PROJECT NO. 278-91 (591-198)

ENGINEERING CORP.
GEOTECHNICAL ENGINEERSPROJECT Water Control Structure at
Salt Bayou

Review of Aviles Report
on Salt Bayou Water Control Structure

BORING 91-198

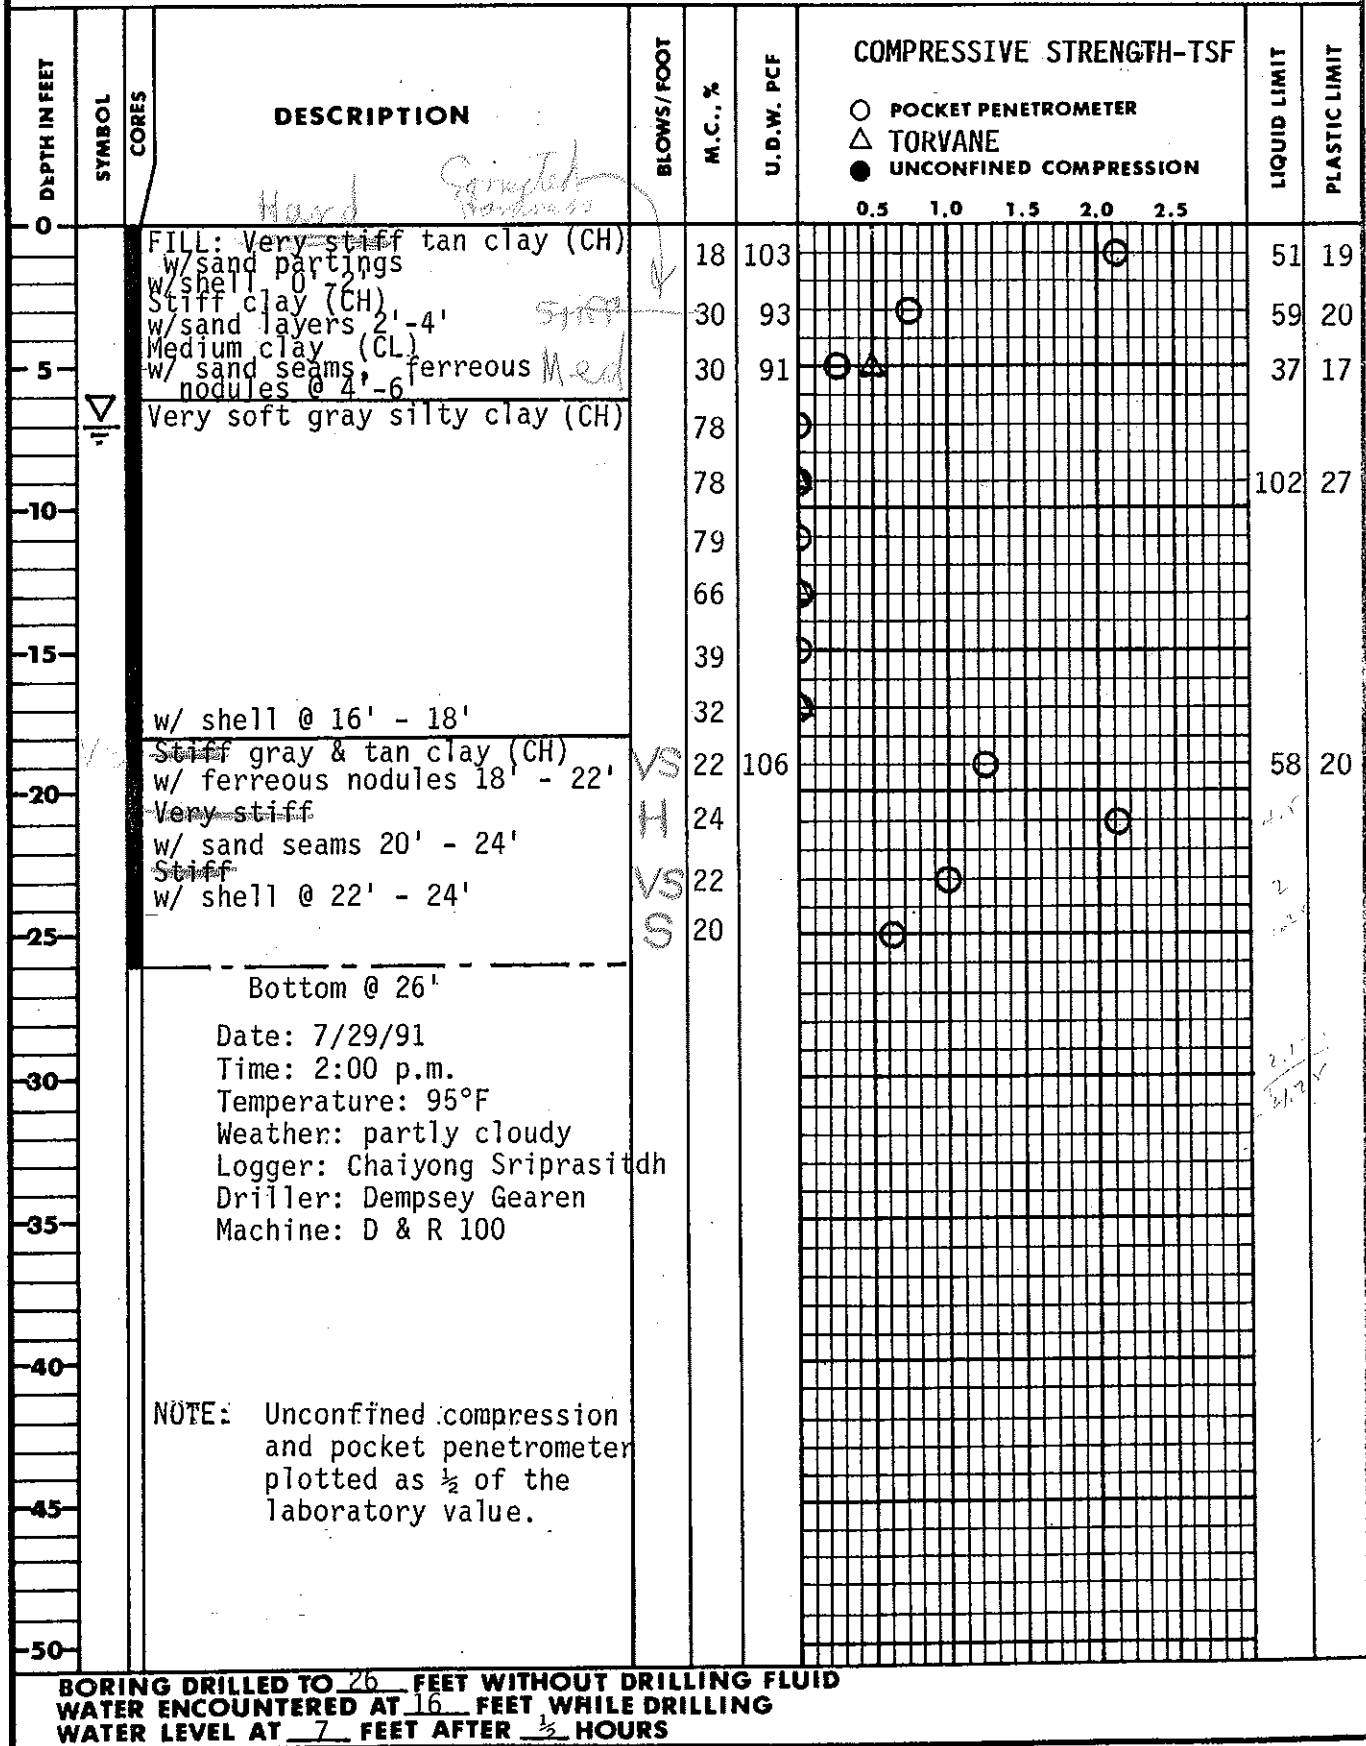
1. The plates showing description of materials, moisture content, unit dry weight, shear strength and atterberg limits are somewhat misleading. The presentation of unconfined compressive stress as a shear strength does ^{not} ~~ent~~ appear appropriate. Shear strength is usually taken as one half the unconfined compressive stress.

2. A comparison of the plots of pocket penetrometer readings with those shown on the driller's log appears to indicate that most if not all of the field readings were used on the plots. The contracts states: "The consistency of undisturbed cohesive materials shall be determined in the laboratory by taking pocket penetrometer readings in accordance with procedures outlined in Paragraph 8.6." Were pocket penetrometer readings taken in the laboratory?

3. A number of the torvane readings shown on the plots indicate no shear strength. What in fact were the torvane readings? A tabulation of the torvane readings should have been presented on the Summary of Laboratory Test Data.
